## **New Jonesborough School K-8**

**SUBJECT:** Site Planning Update

Re: Revised School Site Plan

SITE PLAN  
C1

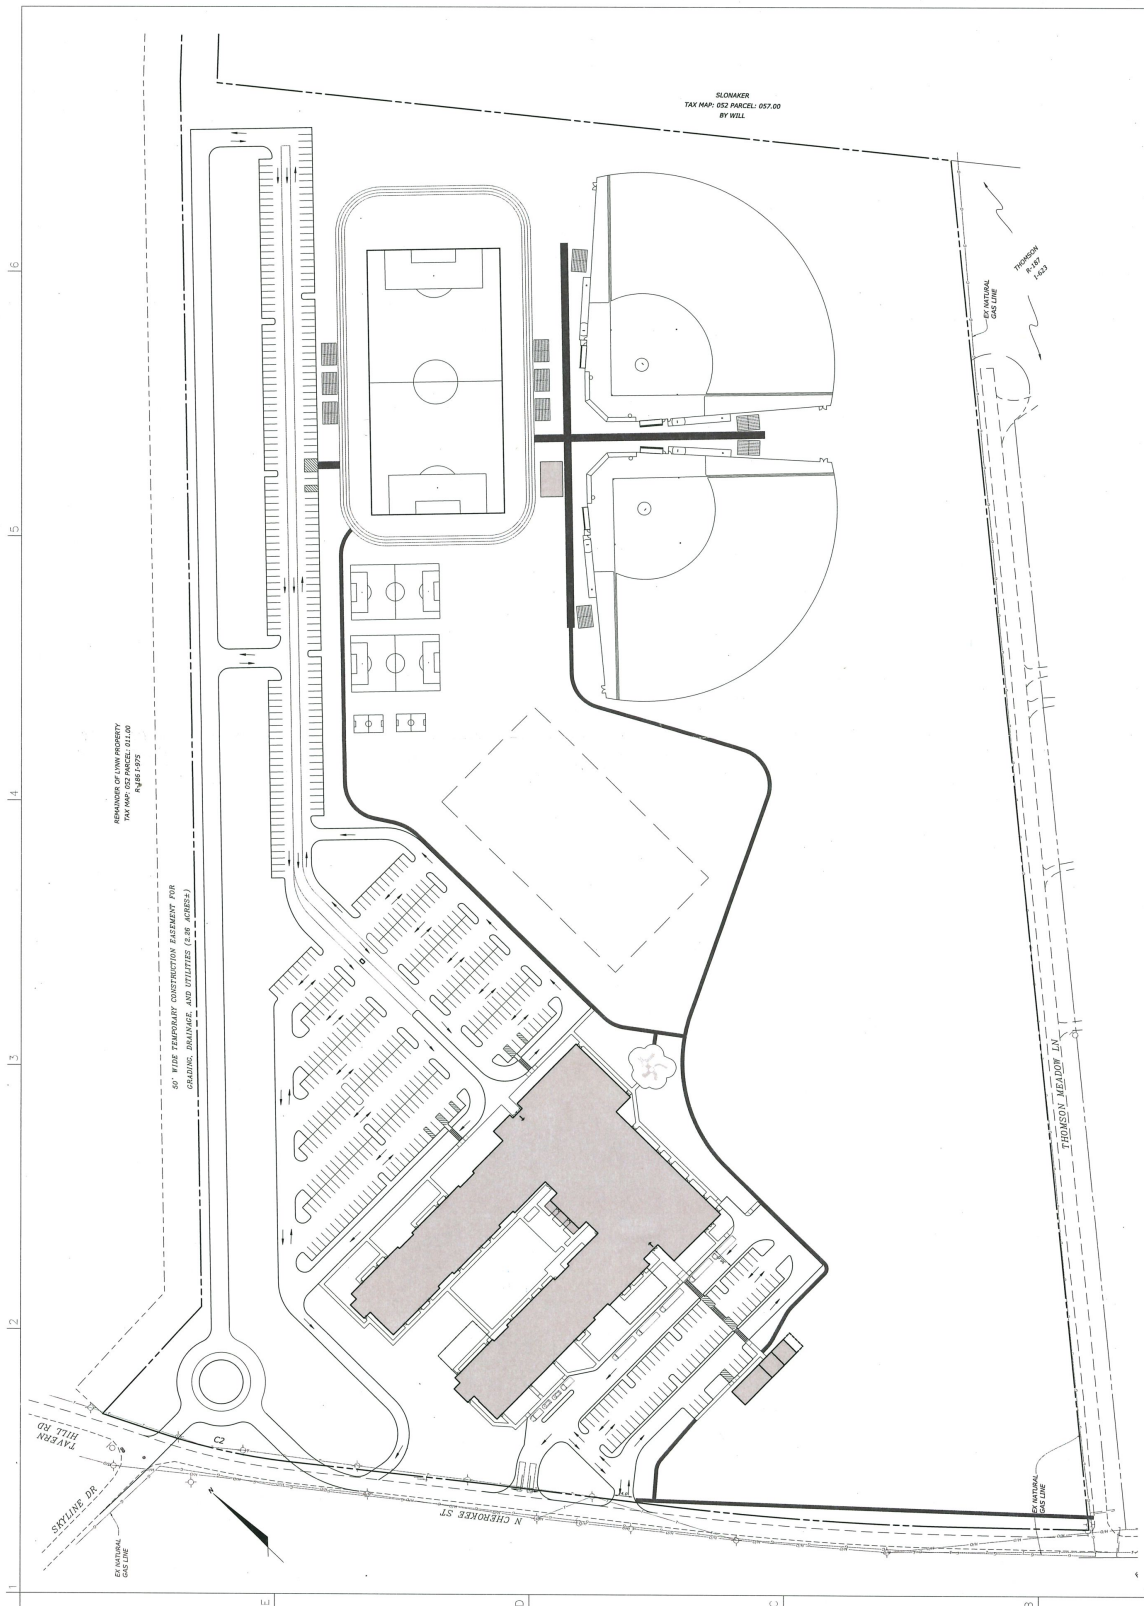
1. Would it make sense to have an acceleration lane, at least a little longer than a bus, to allow buses turning right out of the bus drop-off loop to more easily make that turn onto N. Cherokee Street?

2. Should the sidewalk along the eastside of the school building from the bus loop be wide enough to handle an emergency vehicle, especially an ambulance? Also, should it be a driveway entrance for vehicles at both ends?

3. When factoring in utilities, there should be a couple of yard hydrants within the courtyard area between building wings.
4. Rachel Conger is doing some "homework" on what a CDC playground and pre-school playground should look like. What features should be in either one? Also, the question should be addressed related to possible community use of any playground associated with the school. It really does not make sense to have a CDC playground associated with the school, and then develop a separate one somewhere else for community use. It seems more logical to me to develop a really nice CDC playground that could be used by both the school and the community. It is possible to go after grant funding when there is community use. That raises the question about location. Is there a better location than the one on the site plan? Would the location impact the final grading plan?

While the pre-k playground is probably okay, the same questions above apply to the K-2 playground. We have been told from multiple sources that a playground within a u-shaped building layout is a distraction to students within the 1<sup>st</sup> floor classrooms. I do not see how we can screen out a significant playground set up within the courtyard area. In addition, the question about possible community use is raised. Is there a better location if the intent is to have community and school use? Can we develop a much better playground area if we have access to grant funding? When looking at community use, would it make sense to have a larger playground area that was designed in two sections that were adjacent or closely associated. One for K-2 age children and one for grade 3 and above. Many young families have more than one child, and to split playground area up where it requires

there to be more adult supervision for one family is not helpful. Would there be a better location for a combination playground area that is close enough for school use but fairly easy accessibility to the public? It would seem to be helpful that we make the decision about how the spaces around the school building are actually used and at least determine how they might impact grading and utilities.

5. If a larger playground area for K – above were planned for the eastside of the school building, how much of a problem would it be to have a unisex restroom associated with the school building that opened from the outside? If community use was expected, could access to at least a single restroom be possible without a large additional cost?

Does it make sense for us to assume the worst case scenario when it comes to vehicle stacking? We have talked about the capability of having a northern access drive above the long parking area that expands into two inbound lanes at the east end. In addition, grading of the northern access lane would allow a shoulder area that could be expanded into an additional inbound lane if needed in the future. I realize there is cost involved, but would it make more sense to plan initially for two inbound lanes from the traffic circle? If we are grading and rocking for it anyway, why not at least plan to pave two lanes? I assume at least some of the paving will not be in the building contract (the grading would be). We might need to work towards a commitment with Washington County (Highway Dept.) on paving assistance with the project.

1. I would have two or three additional access walkways from the parking area north of the fields into the athletic area. There is only one shown, and there is no sidewalk along the parking area itself. I do not think we want parents and kids having to walk within the parking area a good distance to get to a suitable access point to the field area. If we add two or three additional access points to the fairly close walkway and track area shown on the plan, then I do not see the need to add a sidewalk along that northern parking area.

2. I am assuming that we will need to have a workshop/storage area that is separate for school use and Town use. They could be in the same building but still be separate. I do not think it makes sense for that maintenance area to necessarily be in the same building as the concession and restrooms. It would seem to me that we would want to separate the maintenance building area away from the hub of public activity. On the other hand, we would want the restrooms/concession building to be in the center of the heavily public use area. Would it make sense to have a separate “shared” maintenance building located down the right field line of the westerly ballfield?

3. Is the idea that deliveries by truck or other vehicles to the concession/restroom building and/or maintenance area be from the parking area down the widened walkway, around the practice track to the widened walkway between the football

field and ballfields? If the maintenance building is separated, the widened walkway would need to be extended to that building location, if it is necessary.

4. There needs to be a little homework on what water access is needed in the athletic field area. If there is a separate maintenance building for school and Town use, there will need to be at least a utility sink and drain within both sections. Would there need to be a concrete slab area with drain that could be used by both the school and the Town to wash off equipment?

I assume the area above Thompson Meadow Lane is left out of the site plan because there is not necessarily a firmly established direction for its development. The question is raised regarding how this area is impacted by the grading of the designed area of the schematic? Does dirt need to be graded into this undefined area? We know from feedback from one of the cross-country coaches that the trail around the entire 48-acres is great for practice. It is also great just as a walking trail. If we are keeping the Agriculture Learning Center building in the plan, then it makes sense to also keep the needed outside components to the agriculture education program. The detention ponds are necessary, so it would seem those contours are needed in the grading plan. If there is an equipment shed off of Thompson Meadow Lane for agriculture equipment, does there need to be water to that building. Both access and water is easily accessible from Thompson Meadow Lane. Whether any structures are shown or even any agriculture-based use areas are defined, it would seem to make sense that the grading plan contours reflect that possible use. Even if the use changes, most other uses would likely benefit from the agriculture-based layout scheme.
